# **ADDENDUM NO. 2**

**SPIETH HALL ROOF REPLACEMENT AND  
MECHANICAL UPGRADE**

**PROJECT NO. 950599**

### Addendum #1 Work Sequence Narrative

Drawing Name: **SYMBOLS, DESIGNATION AND ABBREVIATIONS**  
Sheet No.: **E0.1**  
OF

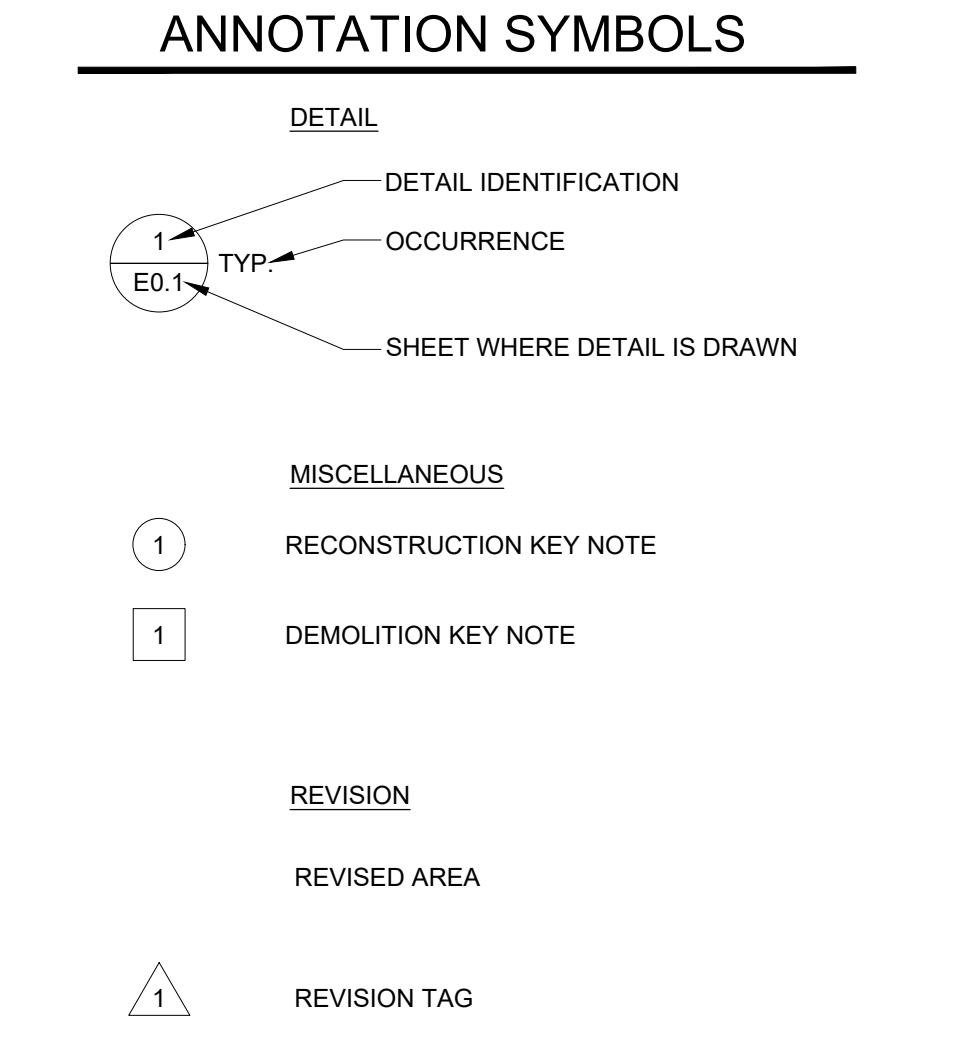
##### Sheet E0.1:

1. Work Sequence added to sheet.

**WORK SEQUENCE**  
ELECTRICAL AND MECHANICAL WORKS FOR THE PROJECT SHALL BE IN PHASES.  
REFER TO PROJECT SPECIFICATIONS, DIVISION 1, SECTION 01014, FOR WORK SEQUENCE OR PHASING AND ADDITIONAL INFORMATION. THE ELECTRICAL CONTRACTOR SHALL ADHERE TO THE STATED SPECIFICATION SECTION AND ALL WORKS SHALL BE COORDINATED WITH MECHANICAL DRAWINGS.

Sheet No.  
**E1.0**  
OF

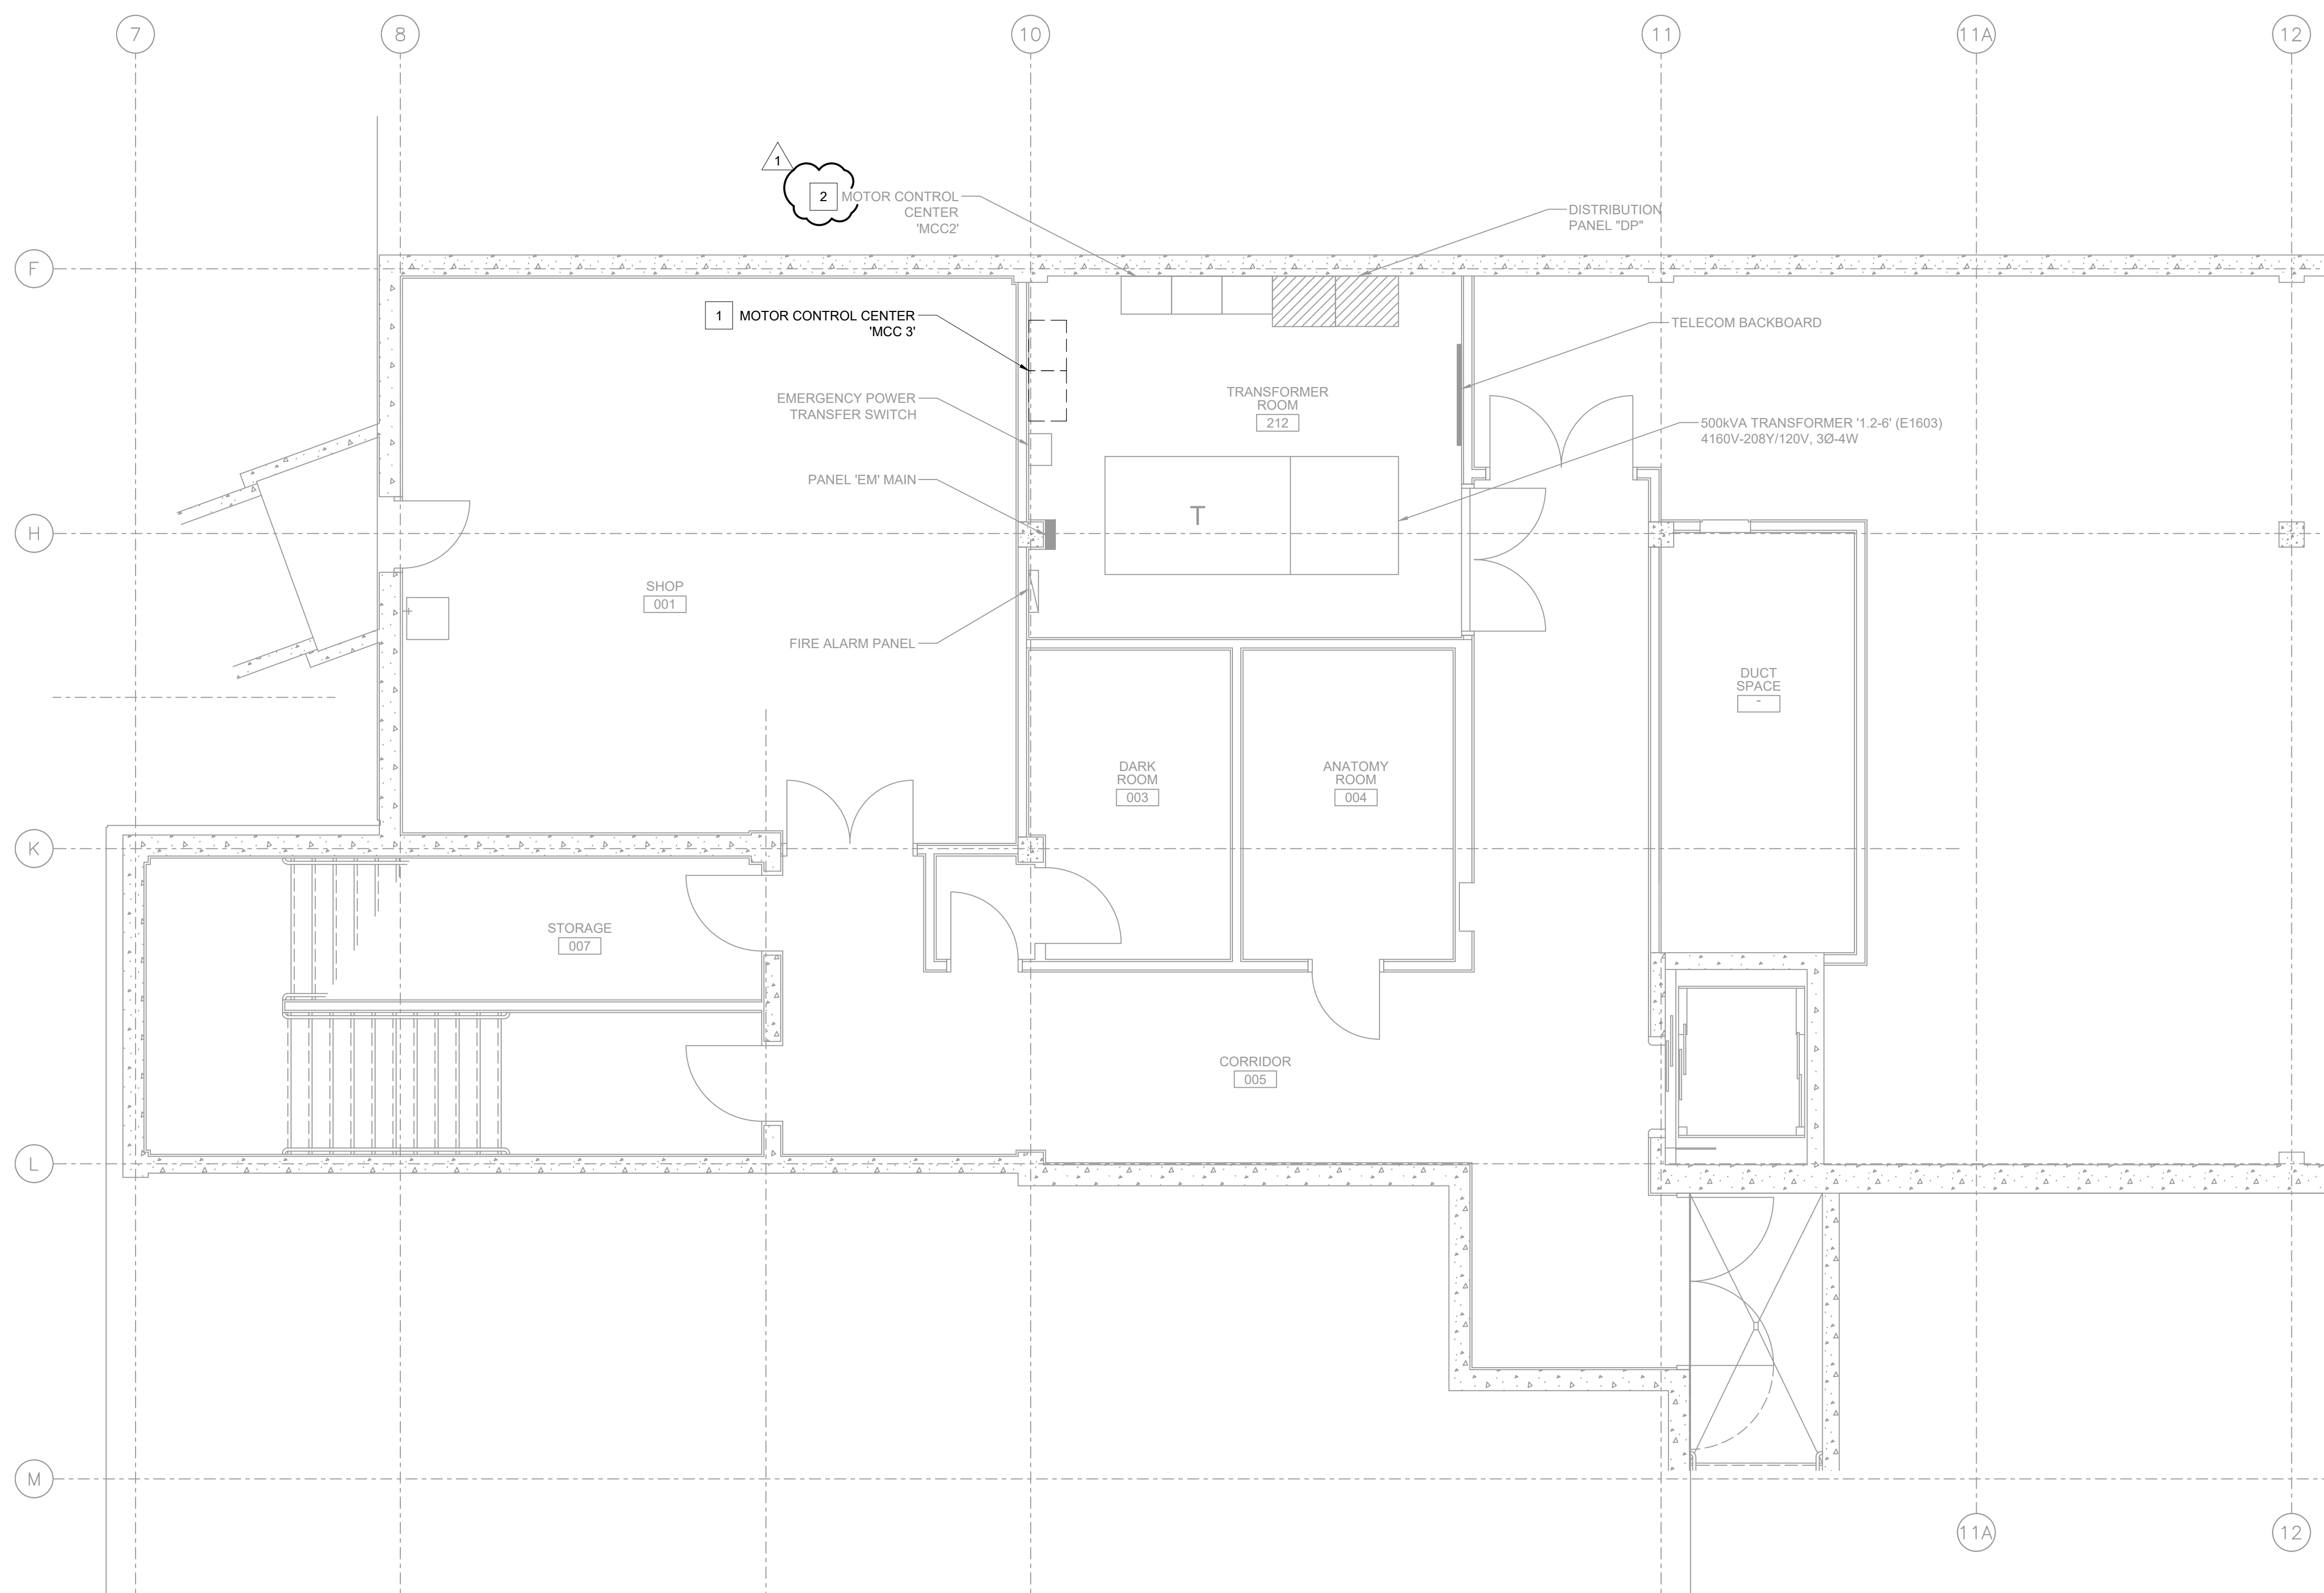
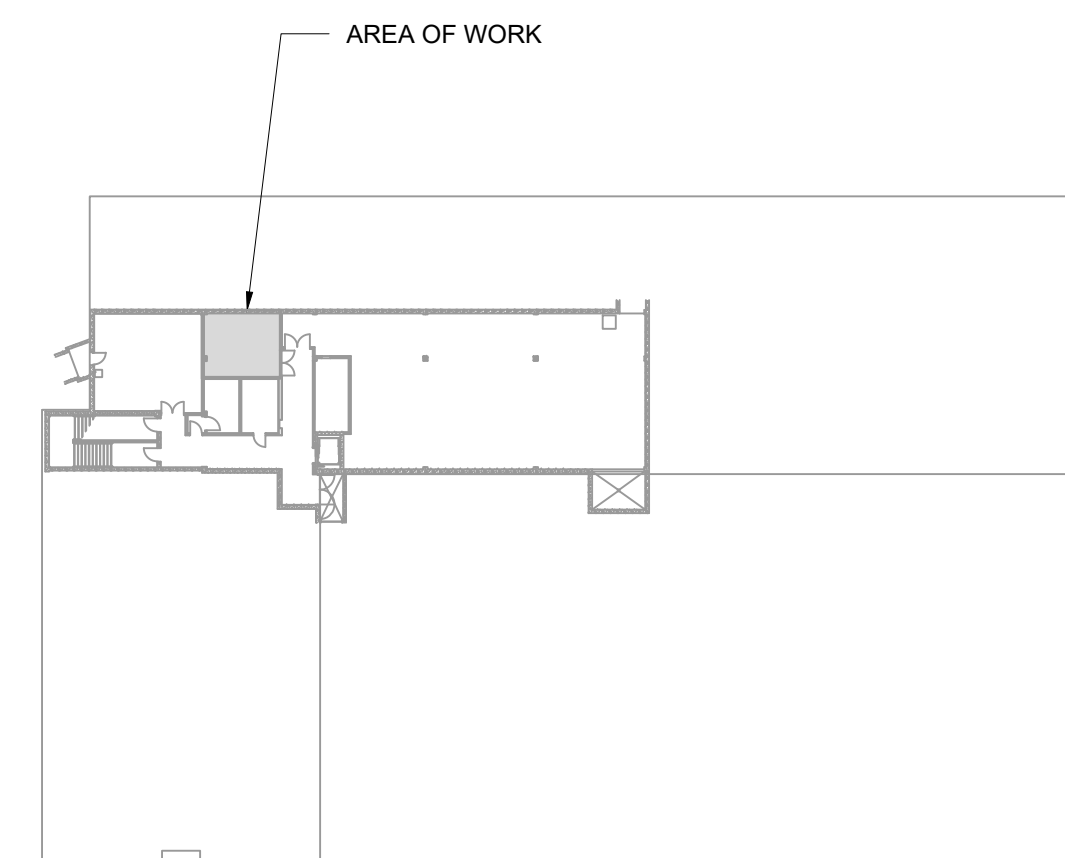
##### Sheet E1.0:

1. Revised note tag on existing motor control center 'MCC2'.
2. Revised demolition note 1, to cite work sequence of decommissioning of existing motor control center 'MCC3'.
3. Added demolition note 2 for motor control center 'MCC2'.

- 1 EXISTING MOTOR CONTROL CENTER "MCC 3" TO BE DEMOLISHED. DEMOLITION WORKS ON EXISTING "MCC 3" SHALL ONLY COMMENCE AFTER THE NEW DISTRIBUTION BOARD "DP-1" IS OPERATIONAL, AND THAT ALL MECHANICAL EQUIPMENT SERVED BY THE EXISTING "MCC 3" ARE COMPLETELY DECOMMISSIONED OR DISCONNECTED. SEE WORK SEQUENCE, ON SHEET E0.1, AND SINGLE LINE DIAGRAM ON SHEET E6.1 FOR MORE INFORMATION.
- 2 EXISTING MOTOR CONTROL CENTER "MCC 2" TO REMAIN AND BE PROTECTED -IN-PLACE.

Drawing Name: **ROOF POWER DEMOLITION PLAN** Sheet No. **E1.3**  
 OF

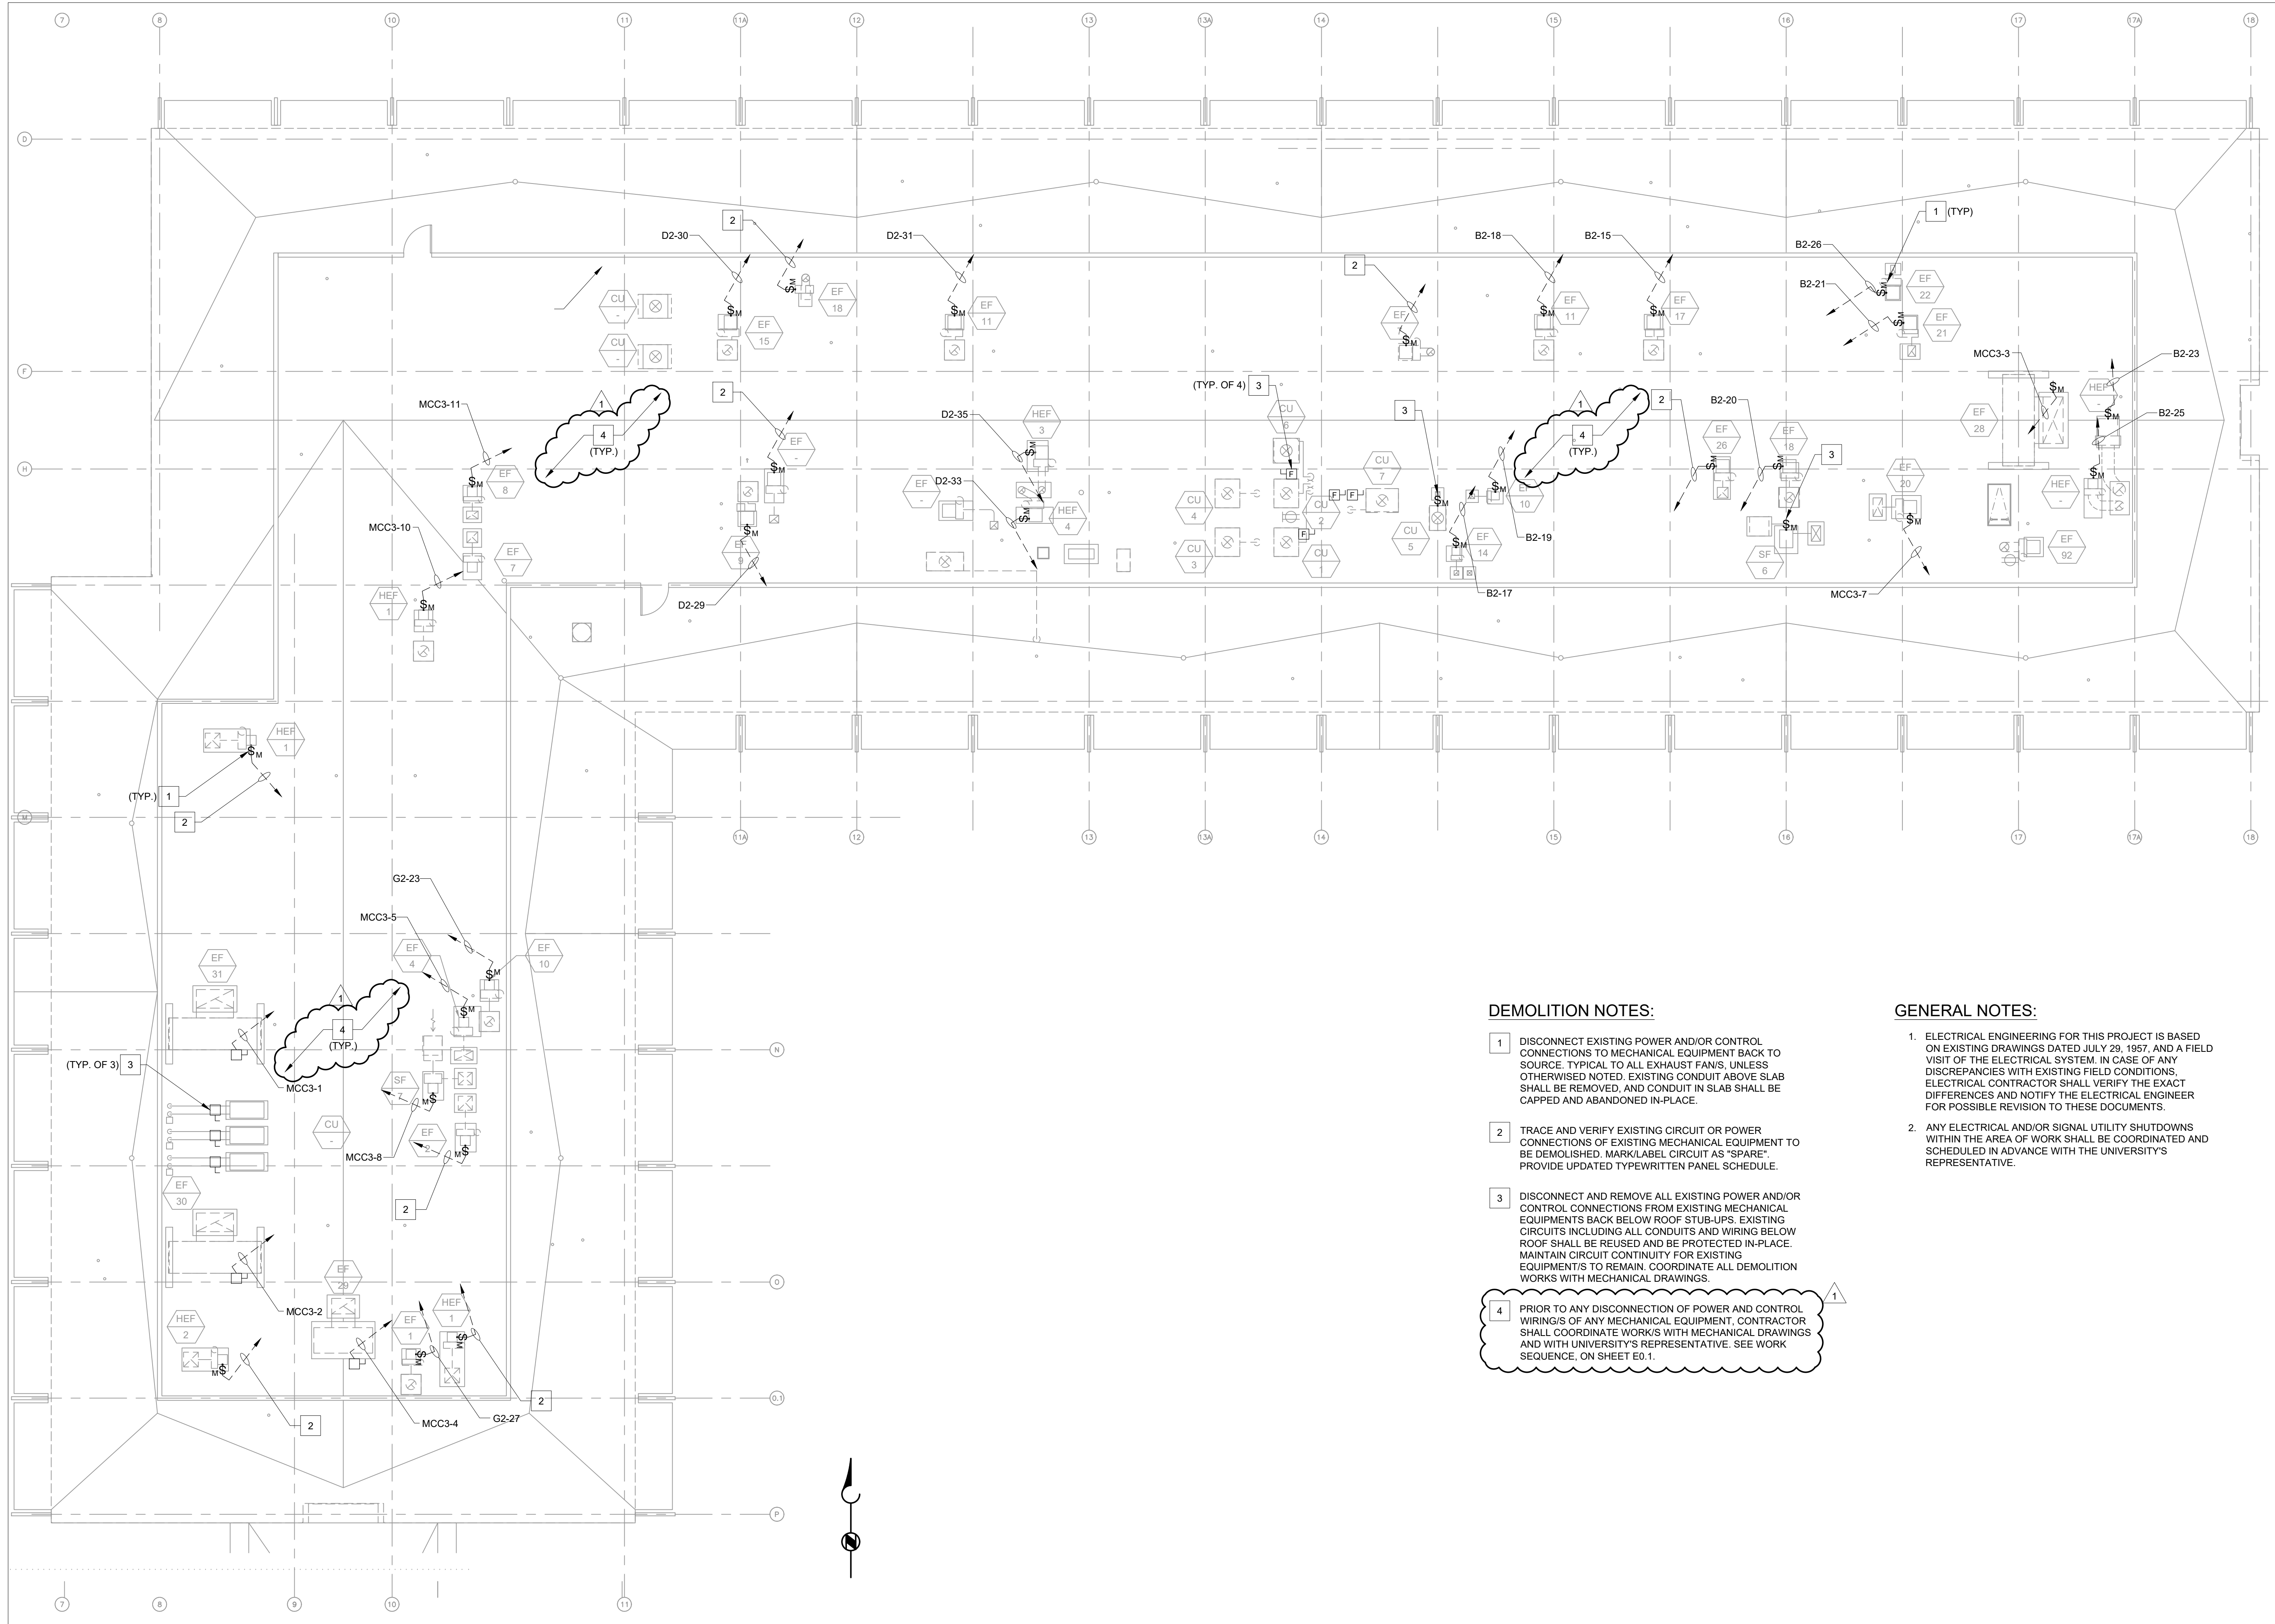
##### Sheet E1.3:

1. Added demolition note 4, for disconnection of existing mechanical power and control connections.
2. Addd note tag 4 to plan.

- DISCONNECT AND REMOVE ALL EXISTING POWER AND/OR CONTROL CONNECTIONS FROM EXISTING MECHANICAL EQUIPMENTS BACK BELOW ROOF STUB-UPS. EXISTING CIRCUITS INCLUDING ALL CONDUITS AND WIRING BELOW ROOF SHALL BE REUSED AND BE PROTECTED IN-PLACE. MAINTAIN CIRCUIT CONTINUITY FOR EXISTING EQUIPMENTS TO REMAIN. COORDINATE ALL DEMOLITION WORKS WITH MECHANICAL DRAWINGS.

- PRIOR TO ANY DISCONNECTION OF POWER AND CONTROL WIRINGS OF ANY MECHANICAL EQUIPMENT, CONTRACTOR SHALL COORDINATE WORKS WITH MECHANICAL DRAWINGS AND WITH UNIVERSITY'S REPRESENTATIVE. SEE WORK SEQUENCE, ON SHEET E0.1.
